**RE: 225 BUNGARRIBEE ROAD, BLACKTOWN (DA-21-00558)
KRISHATHI PTY LIMITED -V- BLACKTOWN CITY COUNCIL (LEC CASE NO. 2021 / 146814)
LETTER OF RESPONSE TO TRAFFIC CONTENTIONS**

We refer to recent correspondence concerning the abovementioned Court proceedings and the Statement of Facts and Contentions (SOFC) issued by Blacktown City Council (Council) dated 14/07/2021, relating to the deemed refusal of Development Application, DA-21-00558.

BUNGARRIBEE ROAD

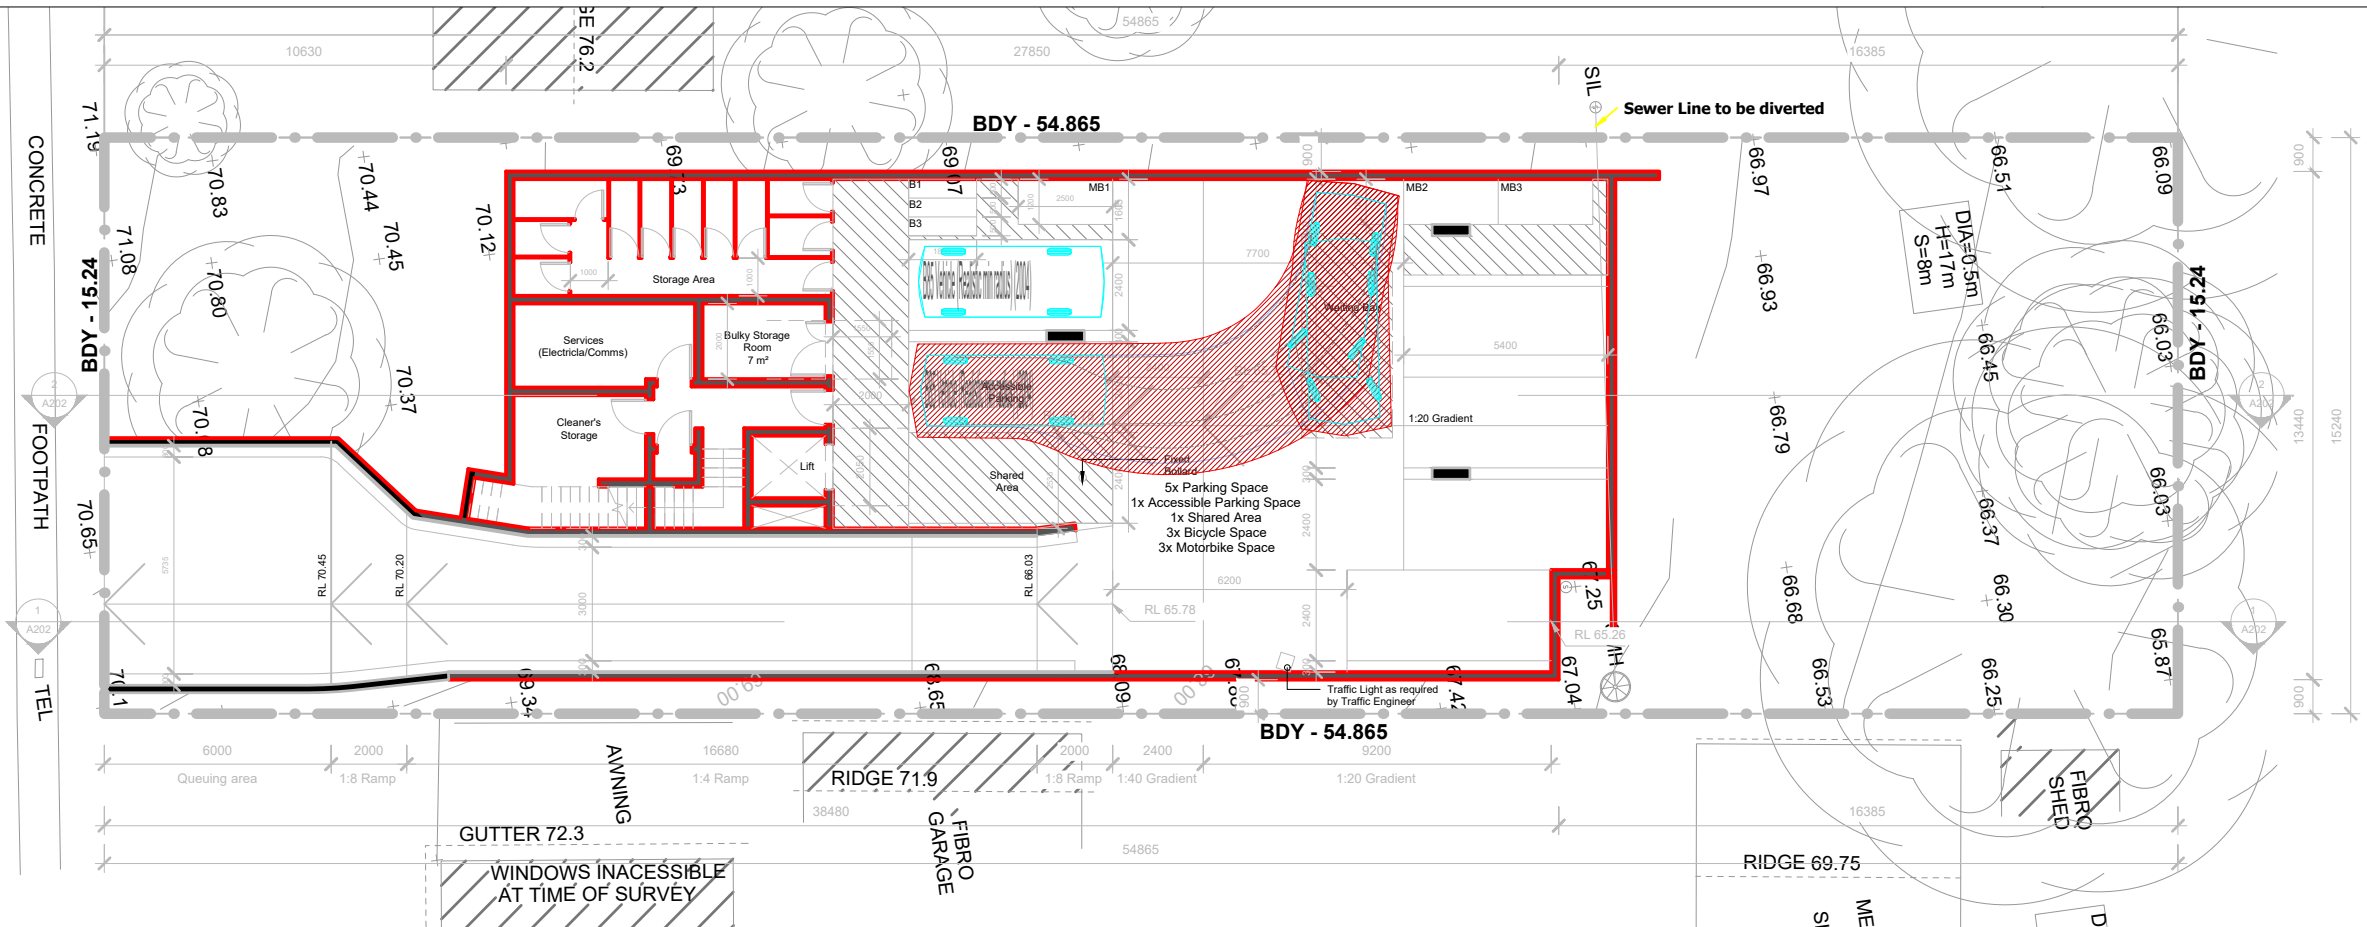
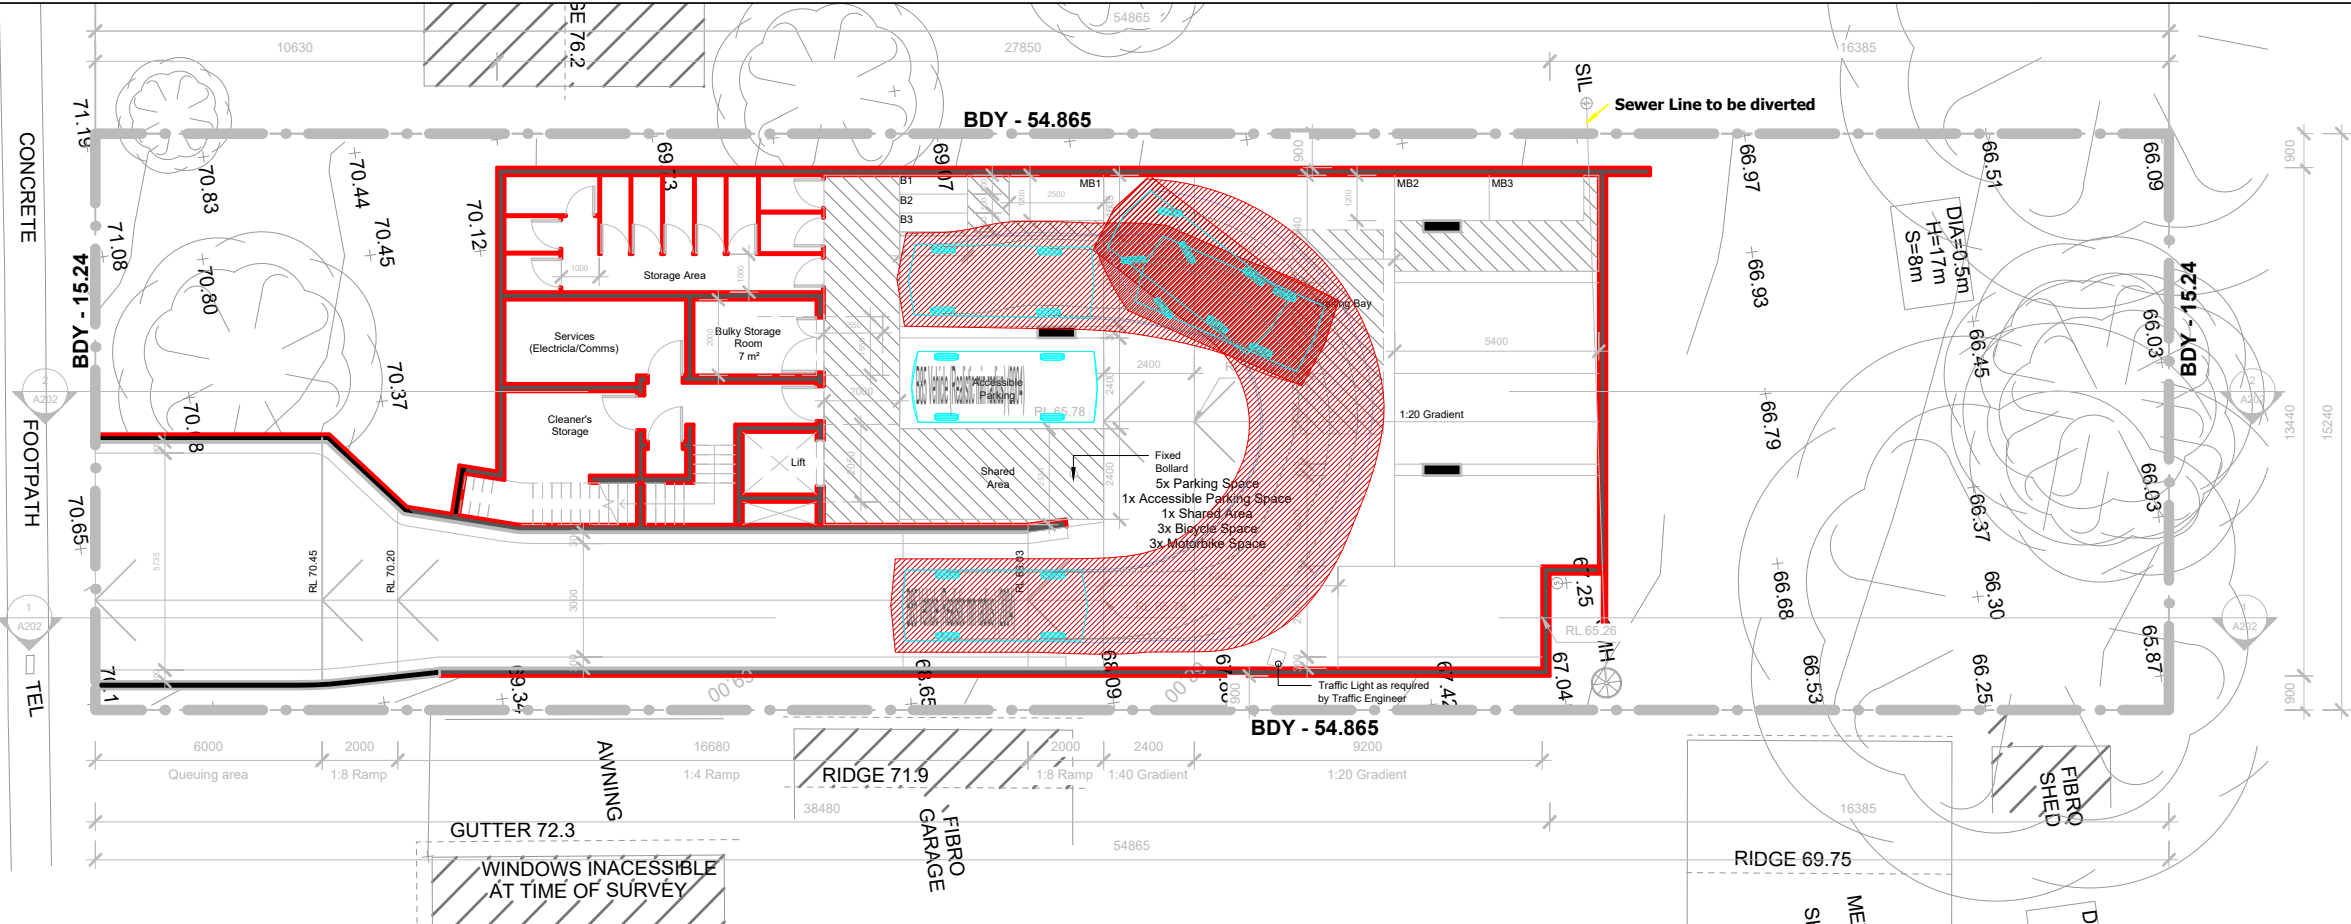
b) Insufficient turning circles have been provided in accordance with Section 2.5.2 of AS2890.1 for passing at the site driveway and within the basement. Turning paths are to be provided for the B99 design vehicle turning left into the site driveway from the public road and passing a B85 design vehicle exiting the site in addition to swept paths for the B99 design vehicle within areas designed for use by one vehicle at a time.

d) Turning circles in the basement are not practical or workable for cars. The results show the required 0.3m vehicle clearance overlapping with high obstructions (walls, columns, motorcycle spaces, kerbs and car parking spaces) which is contrary to the requirements of AS2890.1. It appears 'turn on spot' has been used for swept paths (basement and along the driveway) which is a design flaw not representing realistic vehicle manoeuvres. The dwg files for the swept paths are to be provided.

Updated swept path analysis has been undertaken of the vehicle access with the results provided as **Attachment 2**. The results demonstrate satisfactory turn movements for a:

- B99 Design Vehicle turning left-in and left-out of the access driveway from the public road and passing a B85 Design Vehicle.
- B99 Design Vehicle entering the basement car park and passing a B85 Design Vehicle situated within the waiting bay.
- B99 Design Vehicle exiting the basement car park.
- B85 Design Vehicle entering / exiting all car spaces.

The results demonstrate satisfactory operation of the car park and compliance with Appendix B of AS 2890.1.

As per our respond to Contention 6(b), updated swept path analysis has been undertaken of the basement, including for entry / exit to all car spaces with the results provided in **Attachment 2**.

The 'turn from stop' function has only been used where a vehicle has changed from a forward-movement to a reverse-movement or from a reverse-movement to a forward-movement as is standard practice in the traffic engineering profession. The updated swept path results also show that 0.3m clearances are now clear of all vehicle obstructions including walls, columns, motorcycle spaces, kerbs and car parking spaces.
